Access Compliance Report

Public Rights-of-Way

(Island Curb Cuts)

Intersection ID: 25147	Main Street: CARMEL_ESTATES_RD	Cross Street: REA_RD	Location:	N
ADA ID: 8AF6D608DA35	Curb Cut Type: MedianRefuge2	Initial Pass/Fail: Fail	Overall Compliance: No	Severity Score: 12.5
Codes/Mitigation Info/Possible Solution		Field Measurements/Component Compliance

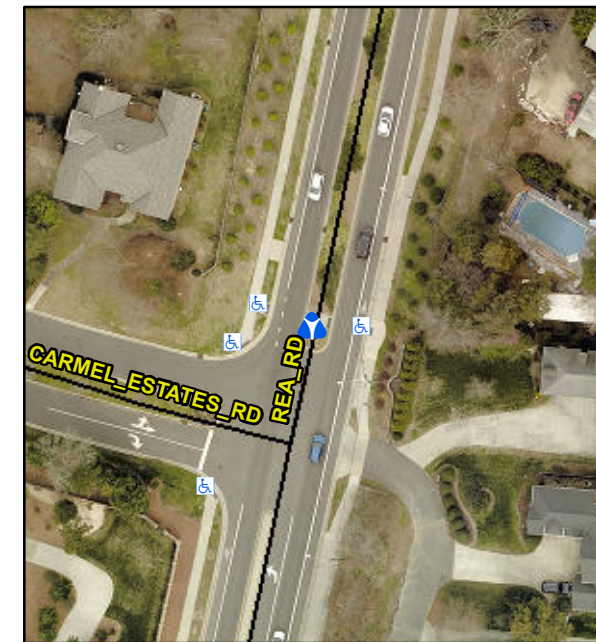
Compliance	Description	Data	Compliance	Description	Data
Yes	Refuge 1 Length (In)	76.5	N/A	Gutter 1 Ponding?	N/A
Yes	Refuge 1 Width (In)	66.5	N/A	Gutter 1 Lip Ht (In)	N/A
Yes	Refuge 1 Slope (%)	2.0	N/A	Gutter 1 Slope (%)	N/A
Yes	Refuge 1 X Slope (%)	3.9	N/A	Gutter 1 X Slope (%)	N/A
N/A	Painted X Walk1?	No	N/A	DWS 1 Provided?	N/A
N/A	X Walk 1 Direction	To W	N/A	DWS 1 Contrast?	N/A
N/A	X Walk 1 Width (In)	N/A	N/A	DWS 1 Length (In)	N/A
N/A	Road 1 Slope (%)	4.9	N/A	DWS 1 Full Width?	N/A
N/A	Road 1 X Slope (%)	1.8	N/A	DWS 1 Offset (In)	N/A
Yes	Refuge 2 Length (In)	76.5	N/A	Gutter 2 Ponding?	N/A
Yes	Refuge 2 Width (In)	66.5	N/A	Gutter 2 Lip Ht (In)	N/A
Yes	Refuge 2 Slope (%)	0.2	N/A	Gutter 2 Slope (%)	N/A
No	Refuge 2 X Slope (%)	6.0	N/A	Gutter 2 X Slope (%)	N/A
N/A	Painted X Walk2?	No	N/A	DWS 2 Provided?	N/A
N/A	X Walk 2 Direction	To E	N/A	DWS 2 Contrast?	N/A
N/A	X Walk 2 Width (In)	N/A	N/A	DWS 2 Length (In)	N/A

Remove & Replace Entire Refuge.
